Product information

Battery Holder NH5077-LF

701111

3.8755.4-1

actual drawing 3.8755.4-1

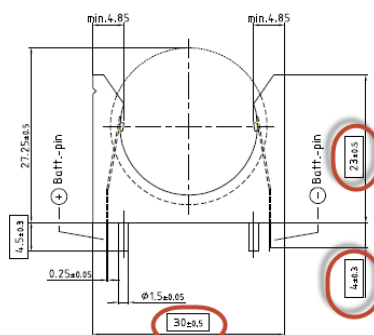
Adjustment of tolerances and pin dimension to current product.
Renata always produced and released battery holder per new adjusted drawing.

Concerned dimensions and tolerances are as below:
Marked dimensions & tolerances are adjusted

adjusted drawing 3.8755.4-2
according real production
